CVS Ashton: Preliminary Plan and Site Plan

Staff Report Date: 12/08/14
revised 12/11/14

***A. Preliminary Plan No. 120140220: CVS Ashton**

***B. Site Plan No. 820140150: CVS Ashton**

SHEET TITLE:
PRELIMINARY PLAN

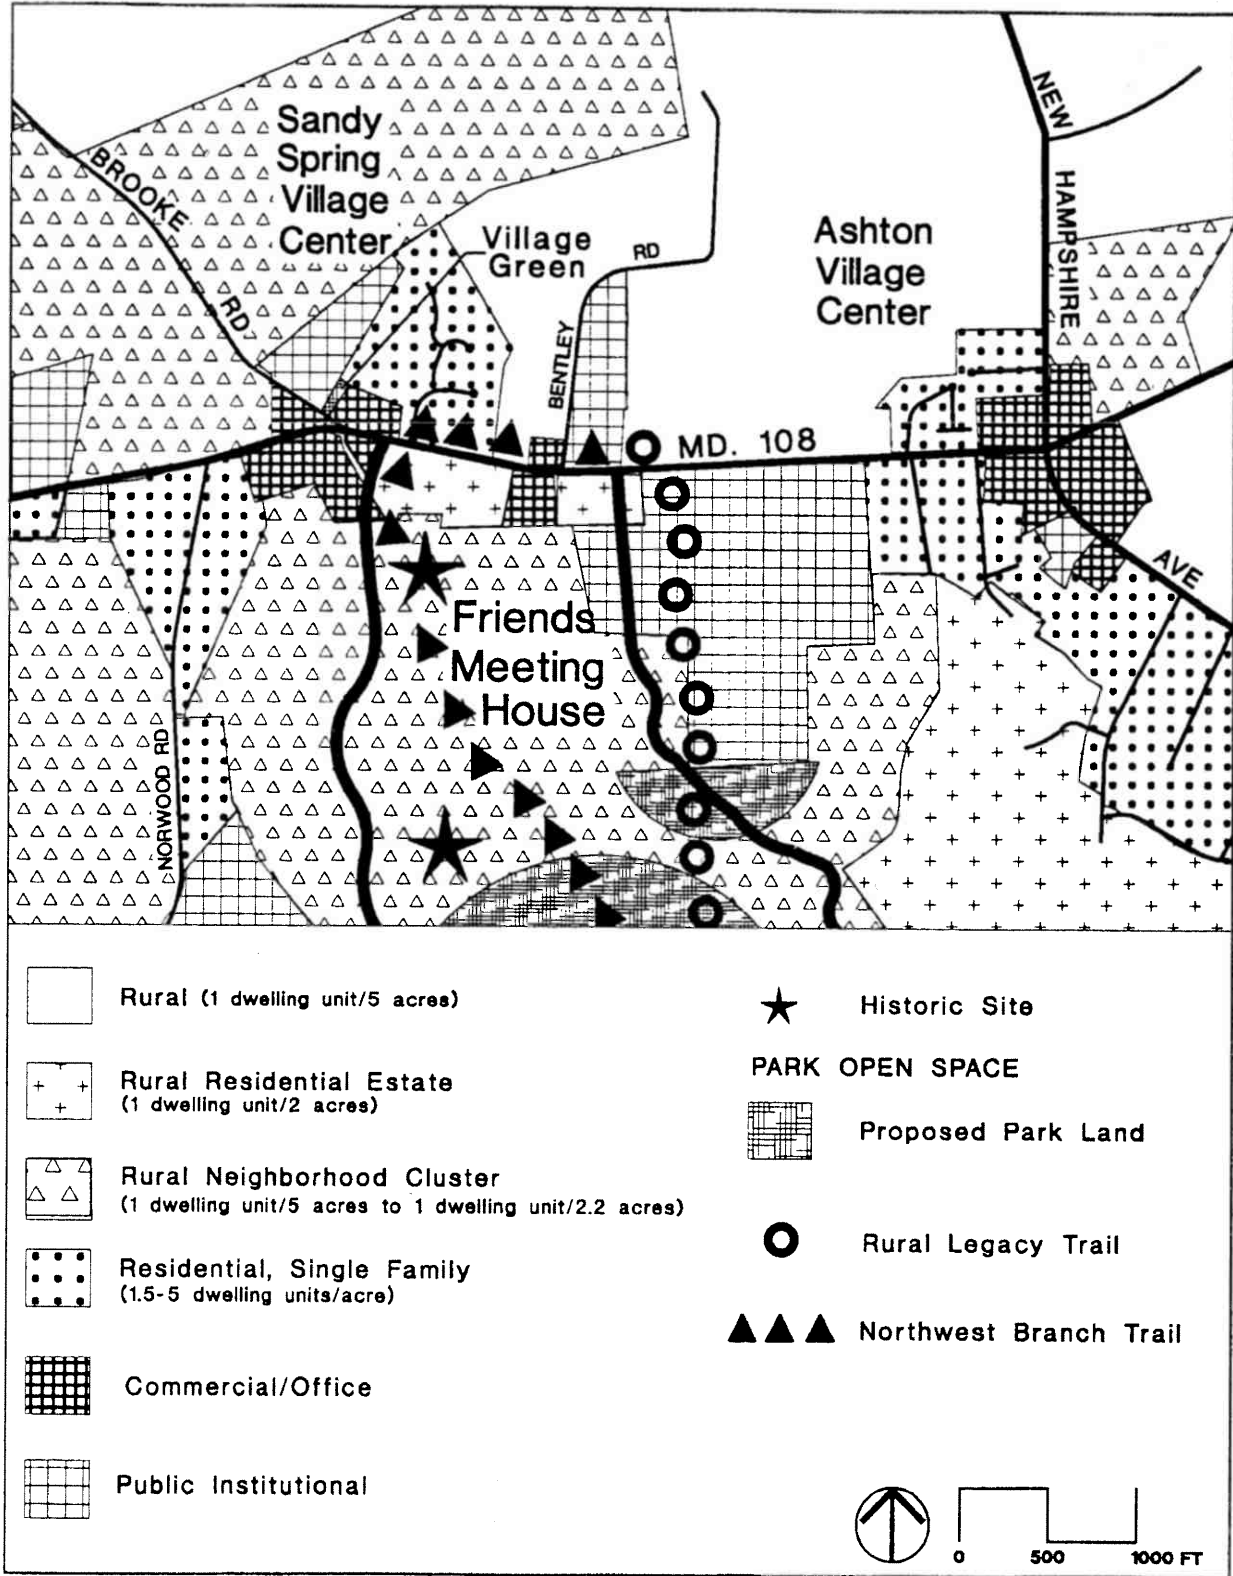
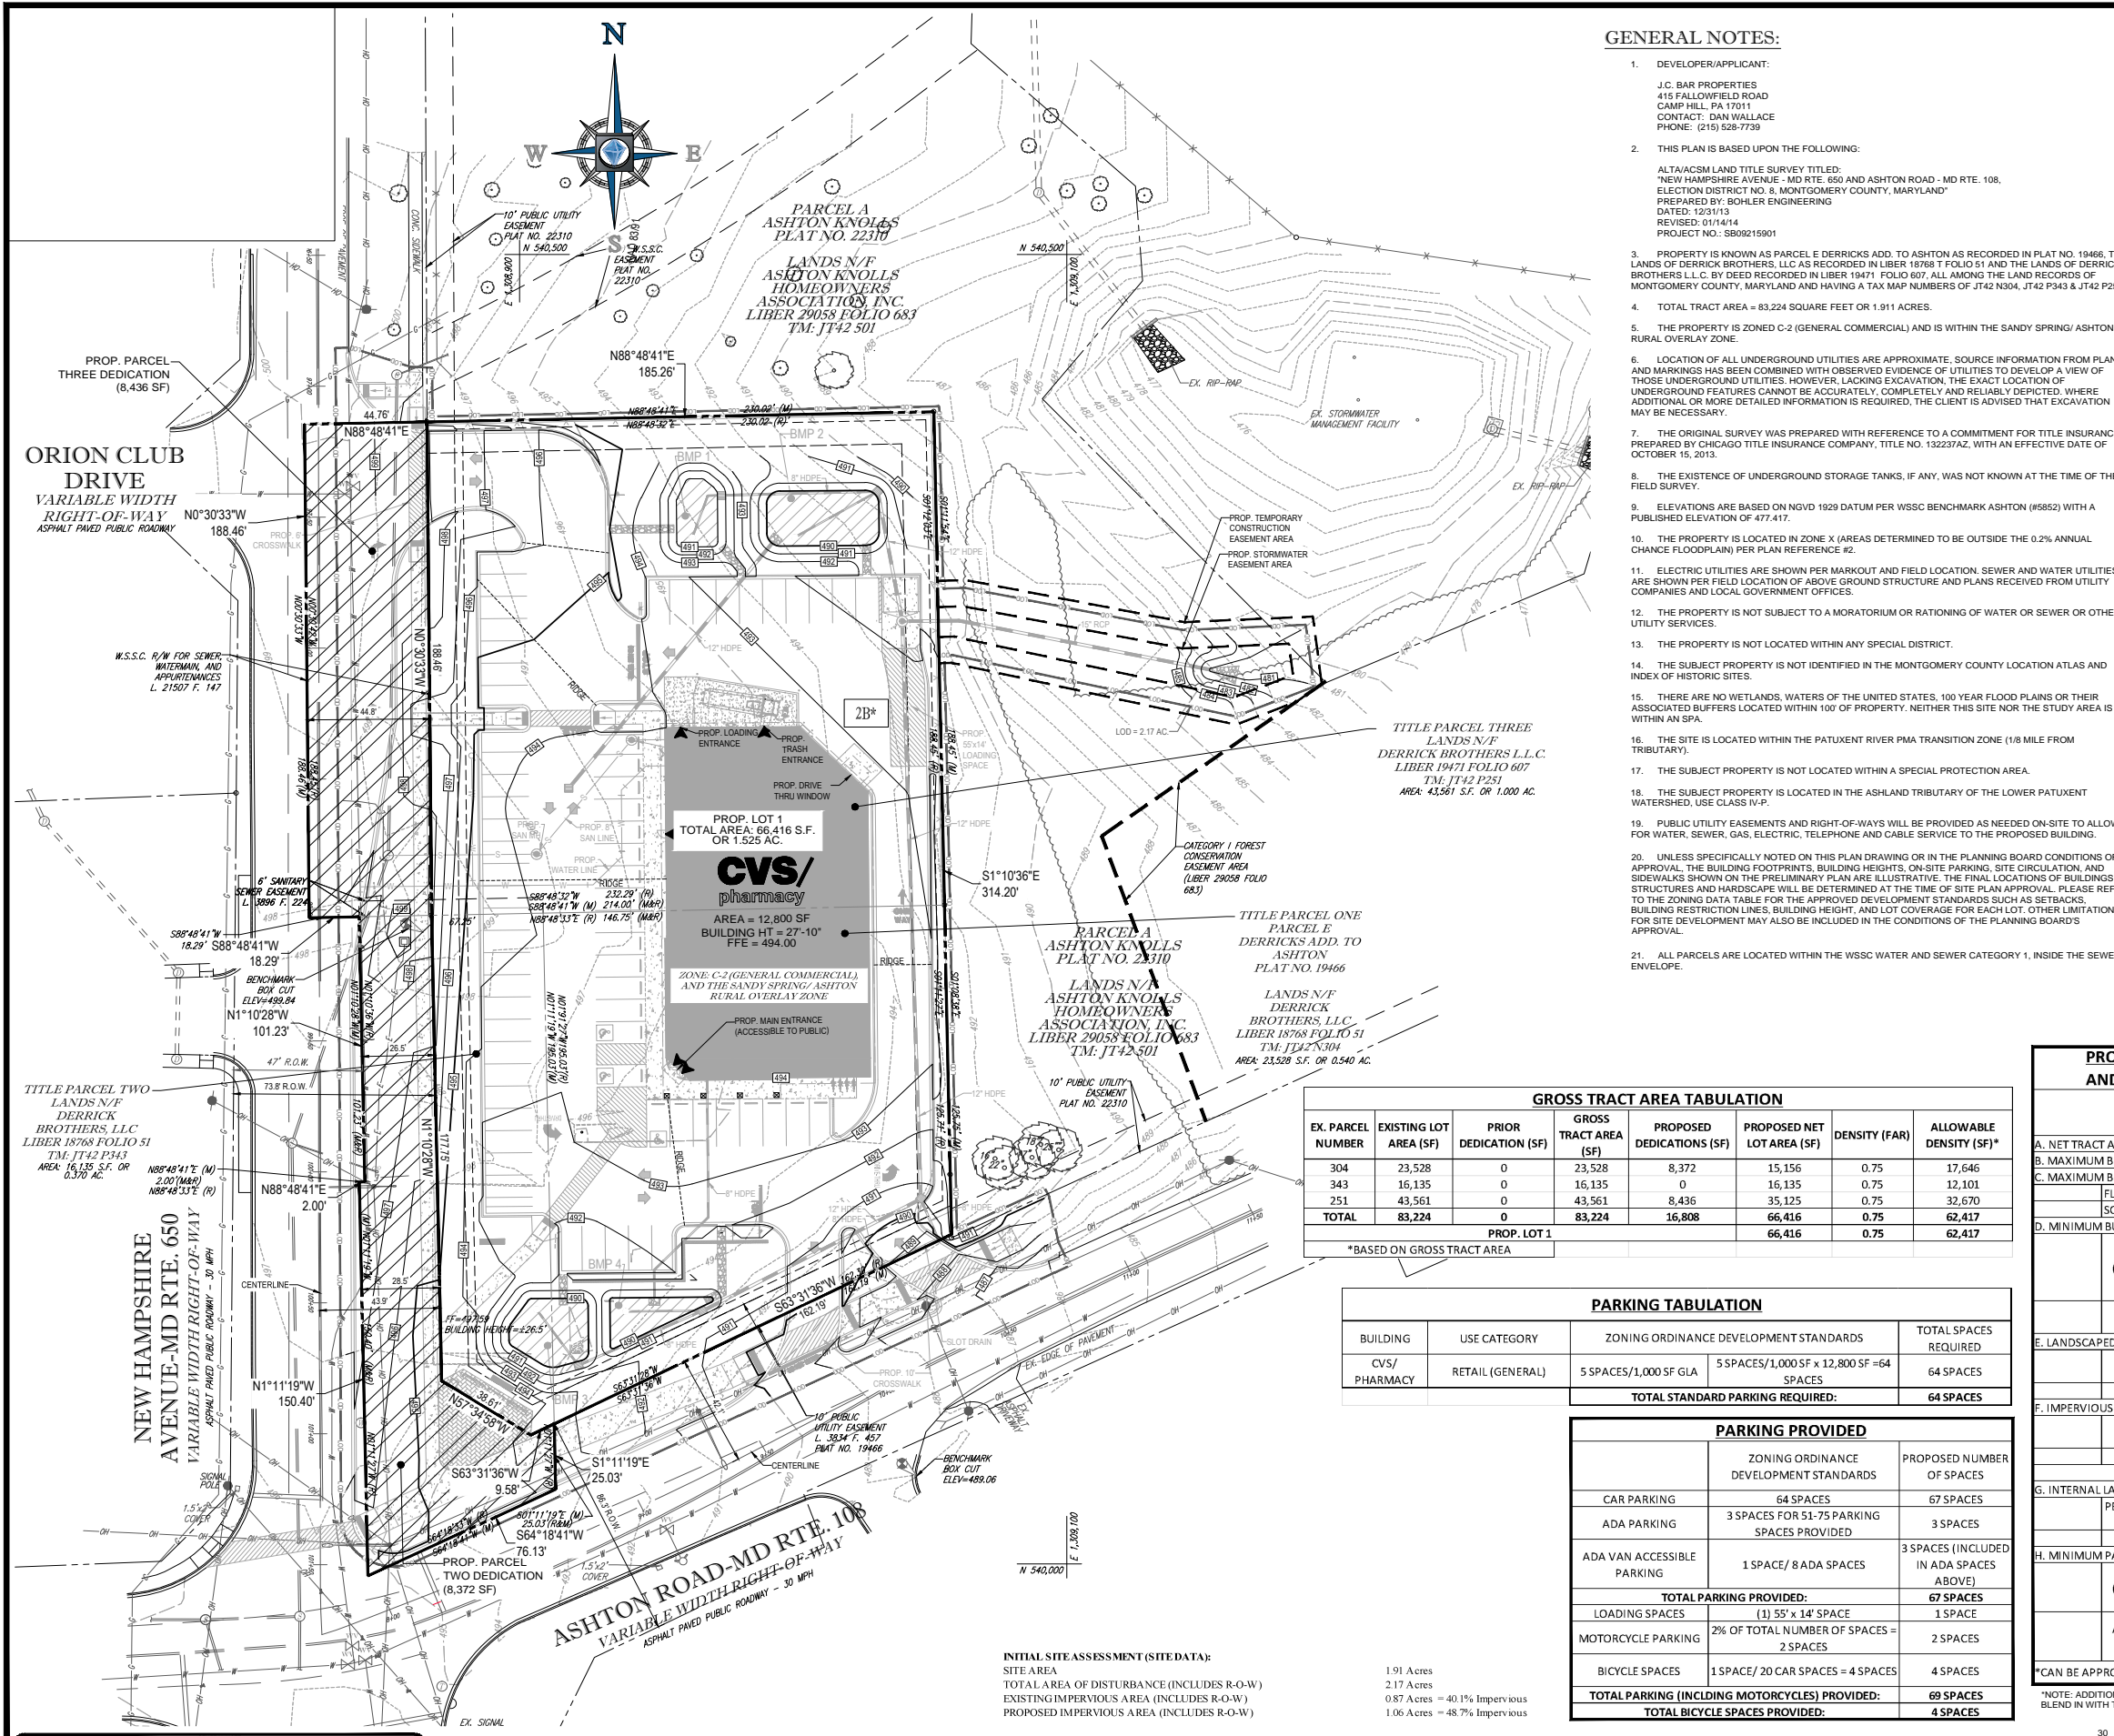
1. Delineate and dimension the dedication for New Hampshire Avenue (MD 650) and Ashton Road (MD 108); show distance from centerline.
 - A. Necessary dedication of Ashton Road (MD 108) in accordance with the master plan. (Note: Ashton Road is designated for a "share use path.")
 - B. In accordance with the master plan, the right-of-way should be 80 feet wide. Necessary dedication of New Hampshire Avenue (MD 650) in accordance with the master plan.

2. The Master Plan of Bikeways recommends a shared use path along Ashton Road (MD 108) and a signed shared roadway along New Hampshire Avenue (MD 650).
 - A. Based on the Master Plan of Bikeways, we recommend the sidewalk along Ashton Road (MD 108) is widen to 10 feet to provide for a shared use path.

- B. The current location of the proposed sidewalk at the intersection of New Hampshire Avenue (MD 650) and Ashton Road (MD 108) does not provide pedestrian access to this intersection; therefore, it is recommended that the sidewalk be moved closer to the curb.

5. The parking lot travel lanes are to be designed to allow a WB-50 truck to circulate without crossing the centerline and the curbline.
 6. The applicant needs to submit a truck circulation plan for review by the M-NCPPC and MCDPS. This plan should delineate the proposed movements on-site between the anticipated access locations, the proposed truck loading spaces, and the proposed dumpsters. The truck circulation pattern and loading position should be designed for counter-clockwise entry and for a left-side backing maneuver. Passenger vehicle travel ways should be separated from the expected truck patterns and storage areas. The applicant may also need to provide documentation of their proposed delivery schedules.

10. Where perpendicular parking spaces border a sidewalk, a two (2) foot vehicle overhang is assumed. The applicant should either provide a seven (7) foot wide sidewalk or wheelstops within those parking spaces.
